SITE REPORT

Job:	190 High Street Review of Seismic Strengthening	Job No:	22815
Issued To:	James Sillay	Date / Time:	27/01/2020 2:00 pm
		Weather:	Overcast
Email cc to:	Ada Huang	Site contact:	James Sillay
Drawing Reference:	SK1, SK2, SK3, SK4, SK5, SK6	Site Report:	#01

Columns C-4 to C-6

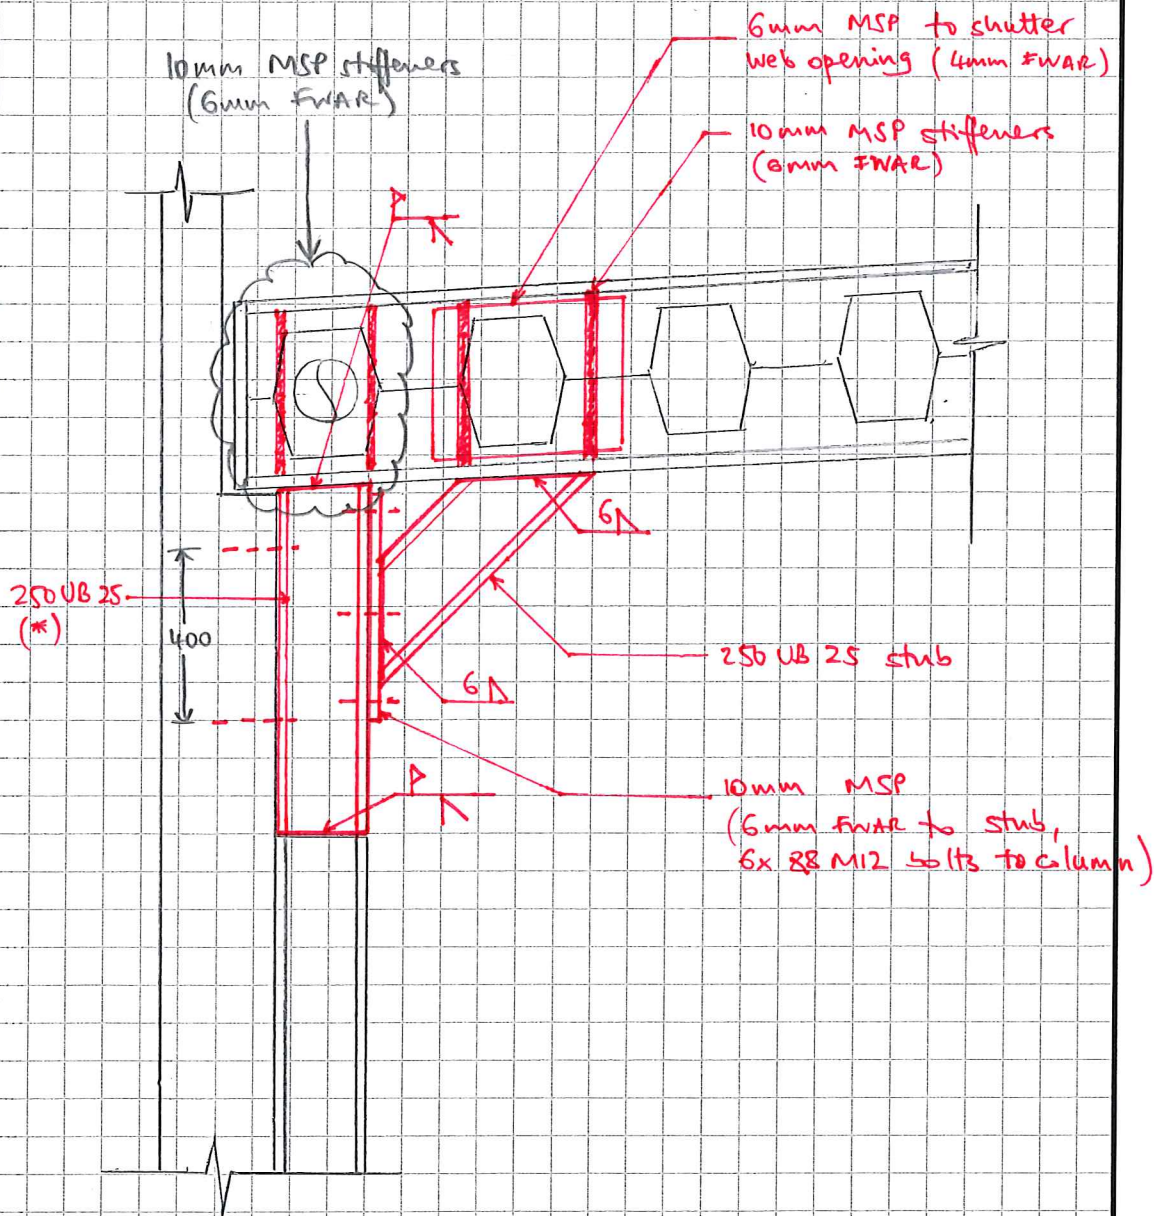
(*) connect to concrete column with
4x Hilti HIT-RE 500 V3 + HIT-V 8.8 M12 70mm embedment
